1st Further Information

**Temporary Shop and Services (Vehicle Showroom) for a Period of 3 Years in
“Other Specified Uses” annotated “Rural Use” Zone, Lots 564, 565 (Part)
and 618 S.C (Part) in D.D. 106, Kam Sheung Road, Yuen Long, New Territories**

(S.16 Planning Application No. A/YL-KTS/983)

Responses-to-Comments

Full Alignment of final discharge

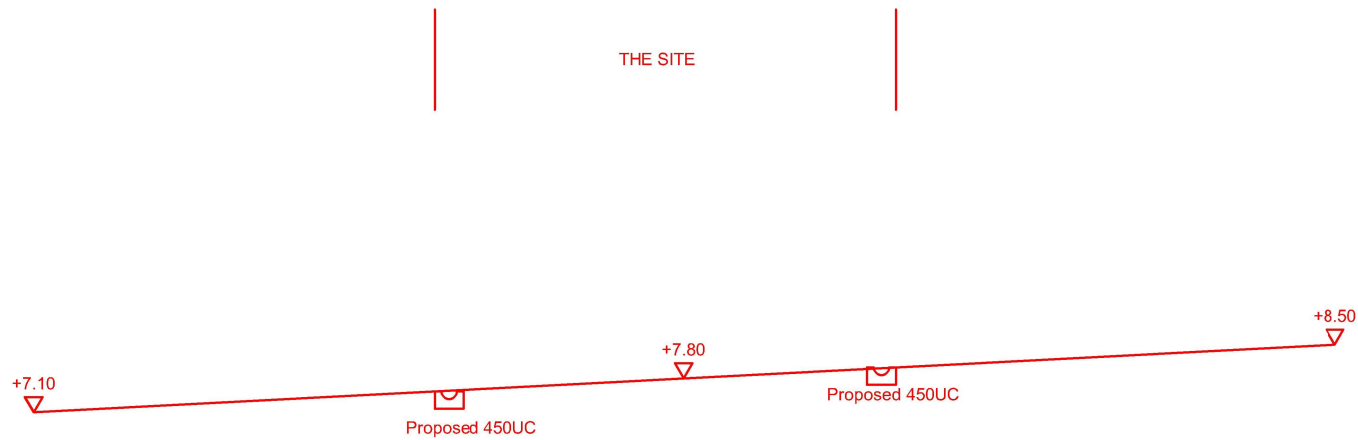
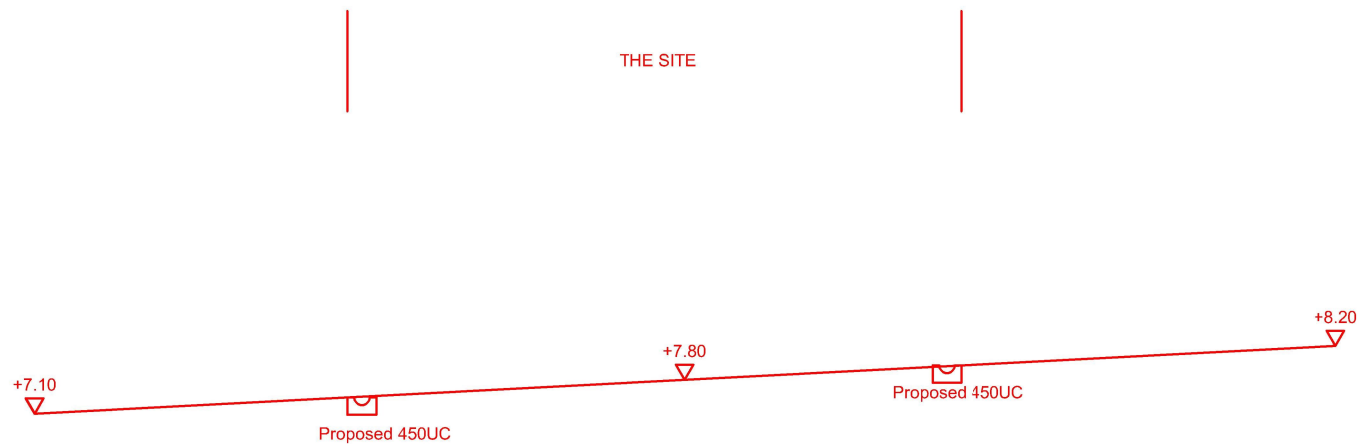
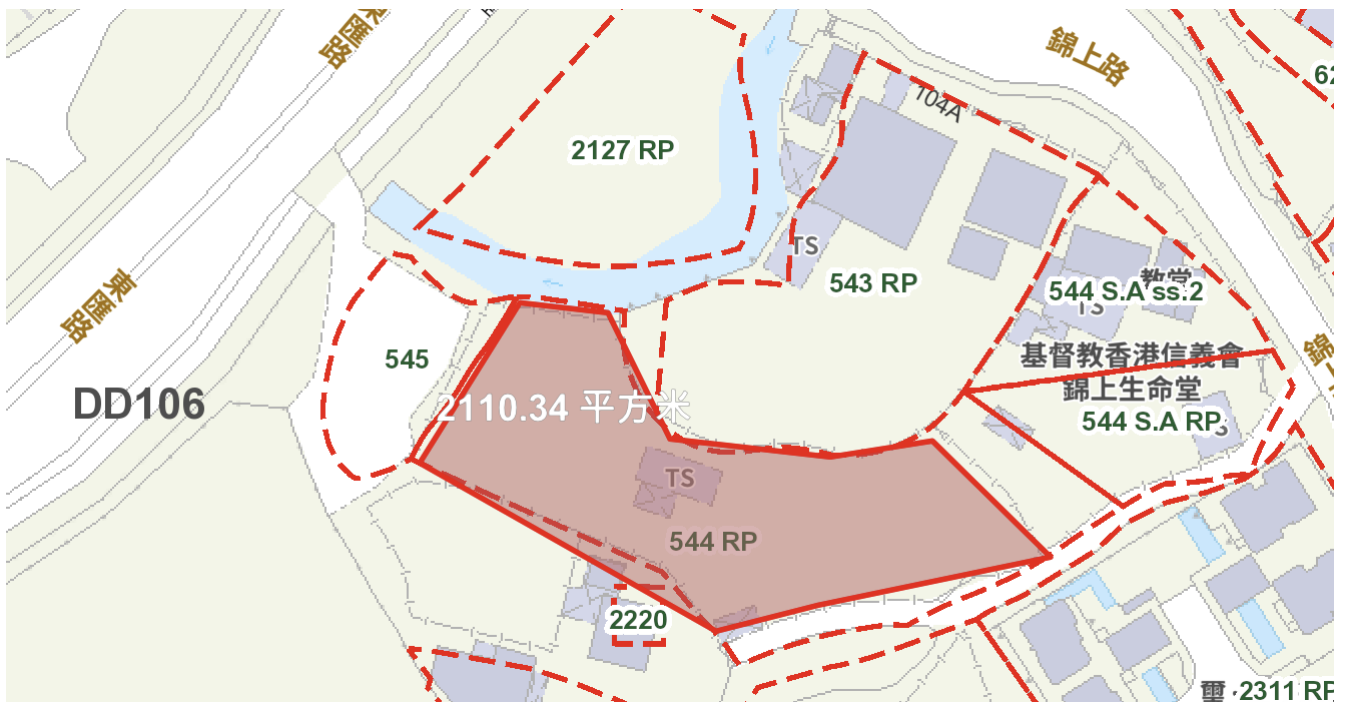
Departmental Comments		Applicant's Responses
1. Comments of Chief Engineer/Mainland North, Drainage Services Department (CE/MN, DSD)		
(a)	Referring to the drainage plan, some locations with change in direction/at intersections are still not provided with manholes/catchpits. Please review.	A revised drainage proposal is provided and revised accordingly (Annex I).

(c)	Please indicate clearly the full alignment of the discharge path (the existing 450mm u-channel) and provide more photos to demonstrate its presence and existing condition.	Full alignment has been provided but path of UC is located in private lot so it is inaccessible for us to take photo.

(d)	Please advise the gradient of the existing 450mm u-channel and indicate on the drainage plan for clarity. The calculation provided on the drainage plan only showing the hydraulic assessment for the proposed 450mm u-channel instead of the existing one. The applicant should check and ensure the hydraulic capacity of the existing	Calculation is provided for justification.

(b)	The proposed 450mm u-channel connecting from the catchpit with sand trap (CP2) to the existing 450mm u-channel is outside the application site and the existing 450mm u-channel seems located within other private lot(s). The applicant should consult DLO/YL and seek consent from the relevant owners for any drainage works to be carried out outside his lot boundary before commencement of drainage works.	Noted. Existing 450UC actually is 525UC.

For existing 450UC,

Catchment area = 2110+4547 = 6657 m²

$$Q = 0.278 C i A = 0.278(250)(0.95)(6657 \times 10^{-6})(3600) = 26371 \text{ liter/min}$$

Therefore, existing 525UC can cater the final discharge

TPLP

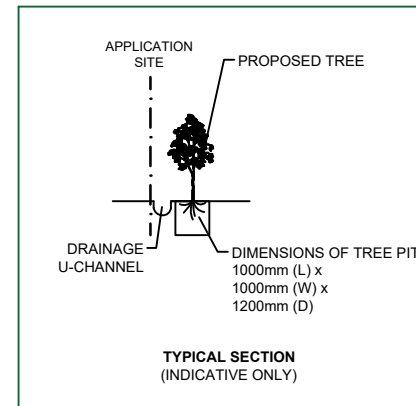
3. Comments of Chief Town Planner, Urban Design and Landscape Section, Planning Department (CTP/UD&L, PlanD)		
(a)	According to their site photos taken in March 2023, there are some existing trees along the site boundary within site. The applicant is advised to indicate the existing trees to be preserved on the Dwg. No. Appendix III – Landscape Proposal.	Noted. A revised tree preservation and landscape proposal is provided (Annex II). A total of <u>32</u> nos. of existing trees will be preserved and 4 nos. of new trees (N1 to N4) are proposed to be planted at the northern portion of the Site. All these new trees within the Site will all be maintained by the applicant during the planning approval period.

(b)	It is noted that the eastern portion of the proposed layout of structure B3 is close to the existing trees along the eastern boundary. The applicant should review and revise the layout of structure 3 to avoid the conflict with the existing trees.

(c)	The 5 nos. of new trees (N1 to N5) proposed in the northern boundary may be in conflict with the existing trees. The applicant is advised to review and adjust the new tree planting location as appropriate.
